From: Robert Reineke <rreineke@ksinghengineering.com>
Sent: Tuesday, April 13, 2021 5:53 PM
To: Pfeiffer, Jane K - DNR
Cc: Shane LaFave; Pratap Singh
Subject: RE: Community Within the Corridor - East Block (02-41-263675) - Next Immediate Steps
Attachments: Figure 1 - Vapor Intrusion Mitigation Plan.pdf

From: [Pfeiffer, Jane K - DNR](#)
Sent: Tuesday, April 13, 2021 4:06 PM
To: [Robert Reineke](#)
Cc: [Shane LaFave](#)
Subject: Community Within the Corridor - East Block (02-41-263675) - Next Immediate Steps

PROJECT TITLE: COMMUNITY WITHIN THE CORRIDOR
2748 N 32ND STREET
MILWAUKEE, WI 53210
PROJECT NUMBER: 40441

VAPOR INTRUSION MITIGATION PLAN

FIGURE 1

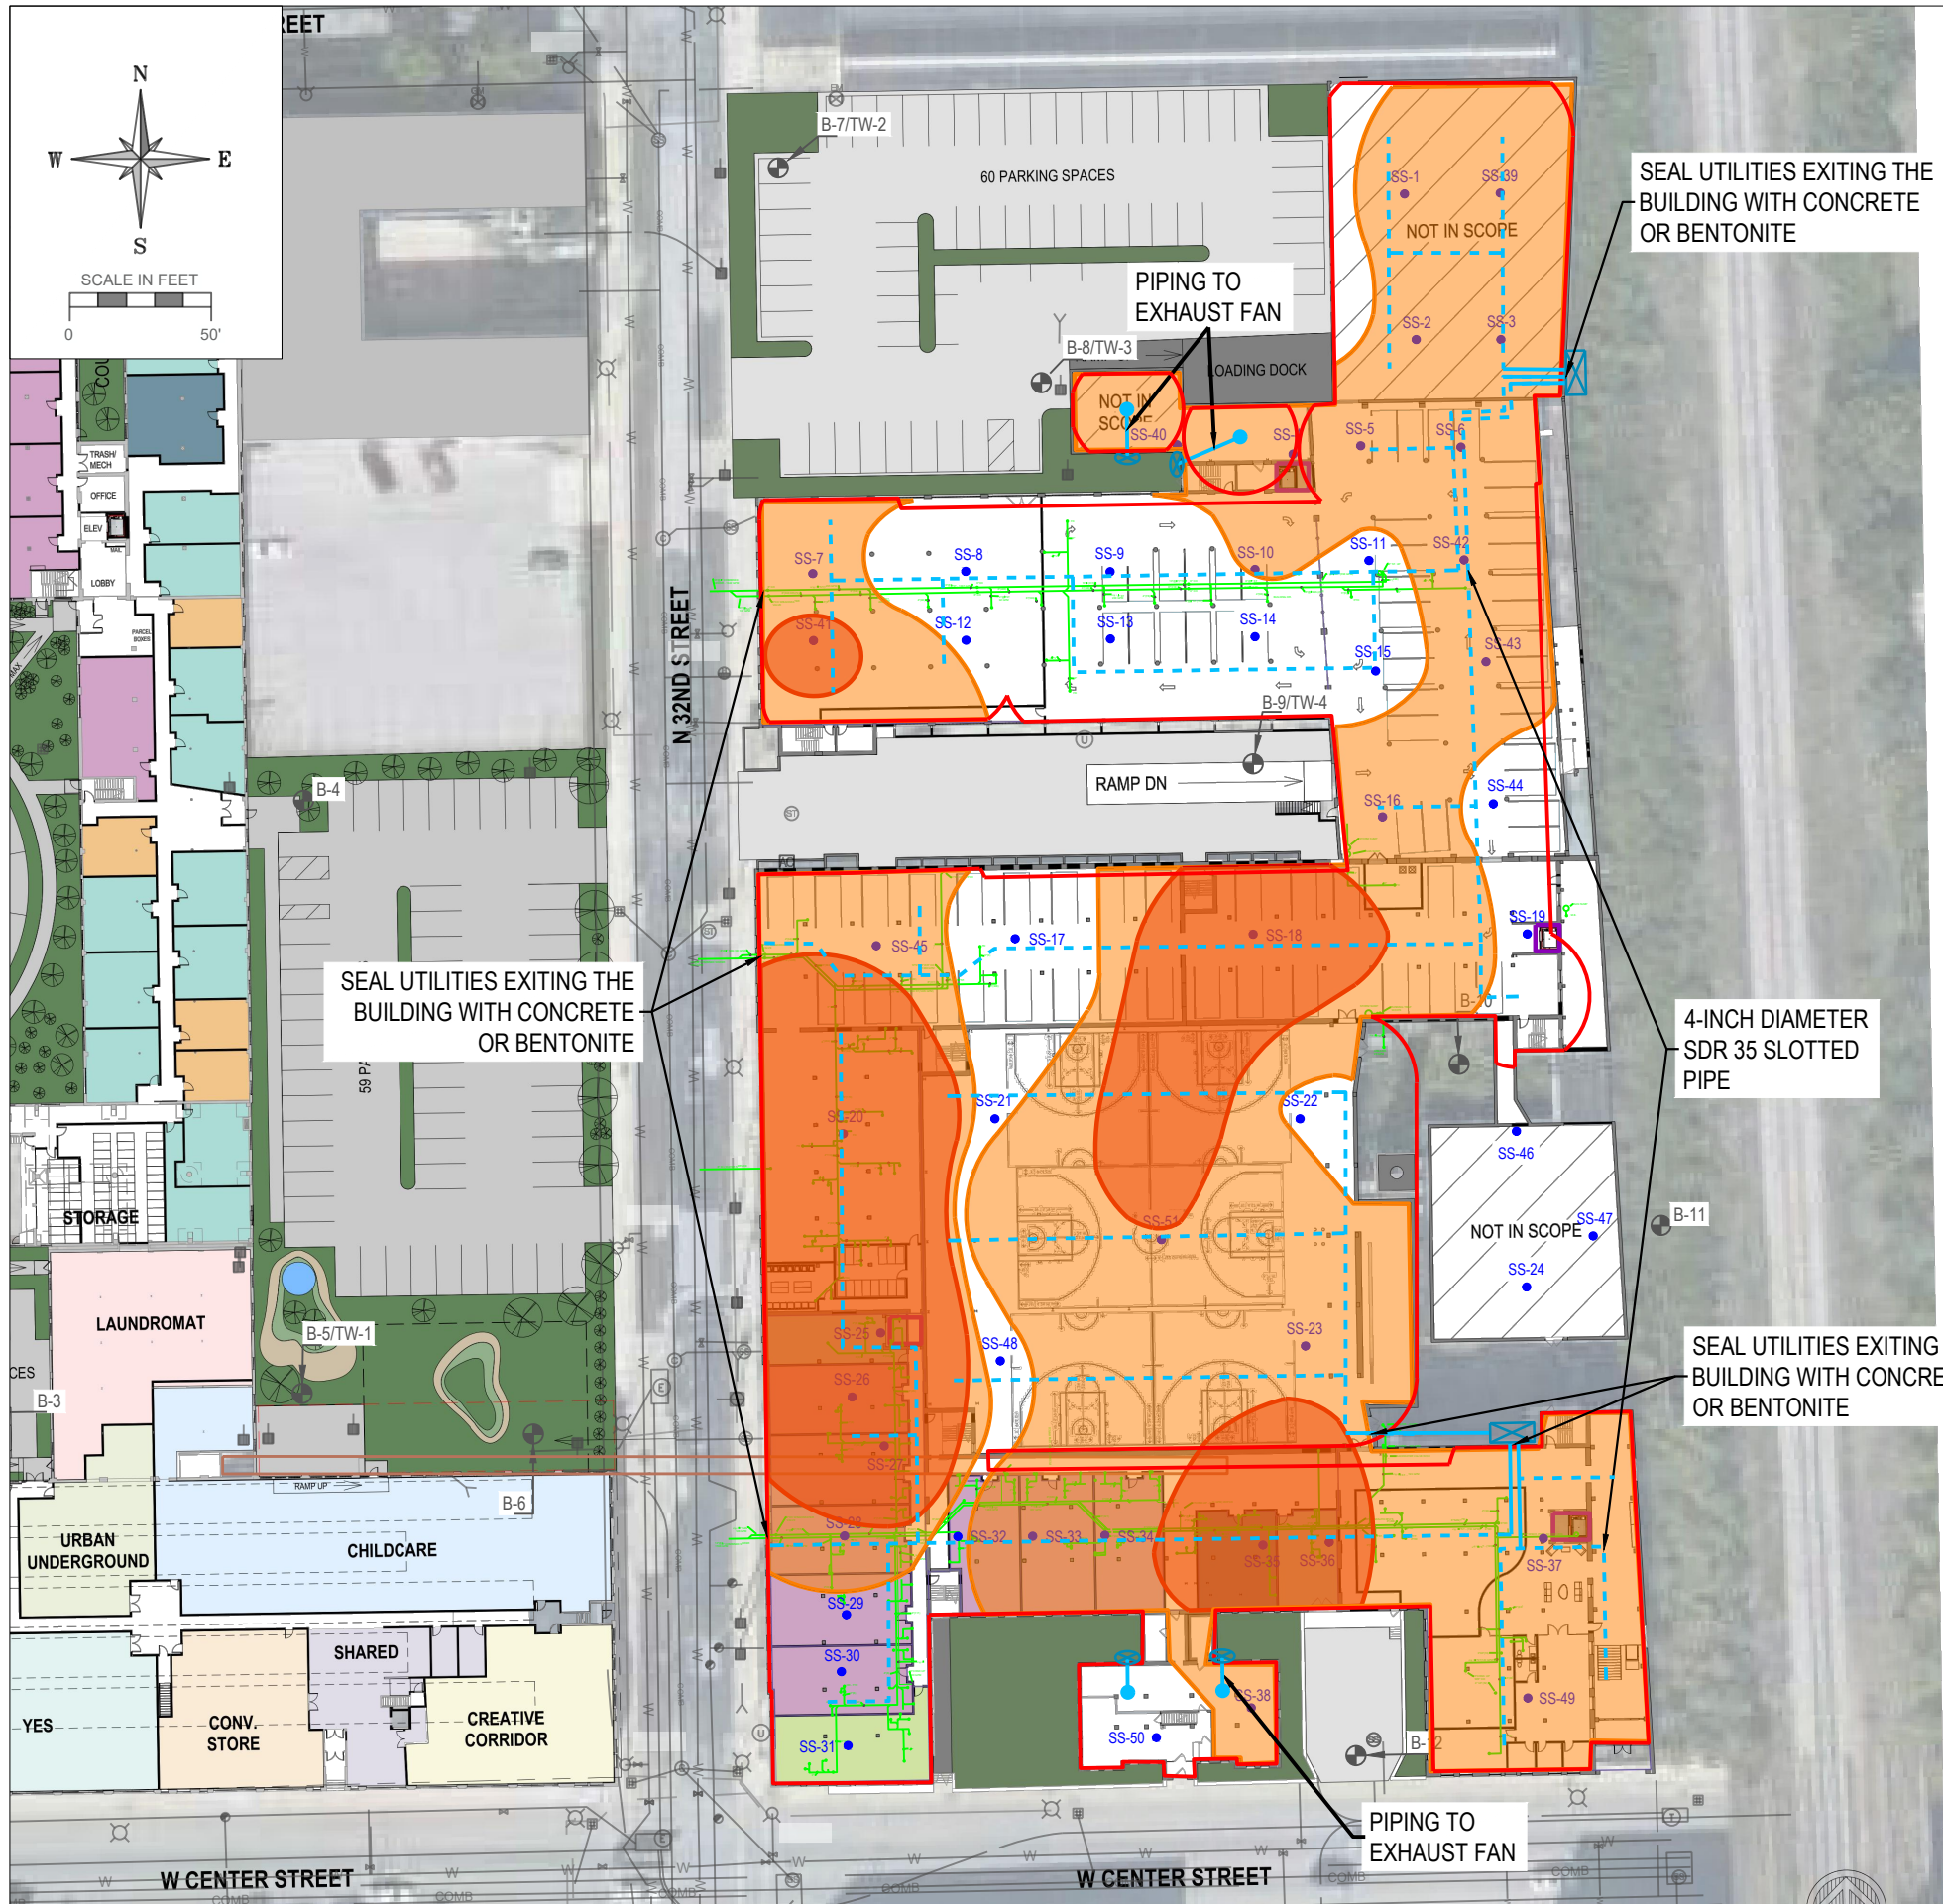
- Sections I.A. and I.B.: In consideration with the requirements and comments included in these sections of the April 9, 2021, DNR letter, provide a revised VMS design report to present a much more robust VMS system. The design report must be revised to ensure that the VMS is effective in all areas of the building, which is essential to create protective conditions for the people that will reside in this structure. Additionally, the design report must include a your preliminary commissioning plan (i.e., pilot testing plan). The DNR suggests that you reference Appendix D, *Commissioning Guidelines*, in RR-800, *Addressing Vapor Intrusion at Remediation & Redevelopment Sites in Wisconsin*, to assist in your development of a commissioning plan.

For information purposes, I'm providing an interim update to the vapor intrusion mitigation plan which covers all occupiable parts of the building.

In the meantime, we are working on addressing WDNR's questions and comments on an expedited basis. I will reach out with questions for parts I find vague or unclear. We do not expect significant changes to the plan, as I noted the mathematical model based on the PFE test is the basis of design and WDNR did not provide any direct critiques of the mathematical model, but I'll endeavor to make the WDNR as confident as possible with our plan. Ultimately we do have the same goals, prevent TCE vapors from getting into the building, protect indoor air quality, provide a sub-slab depressurization system that's effective for the whole building, and remove TCE and other contaminants from the site ensuring that there are no long term risks. But, we at least need WDNR conceptual approval so that we can move forward to the pilot scale testing and commissioning process so that we prove that the system is working or make adjustments.
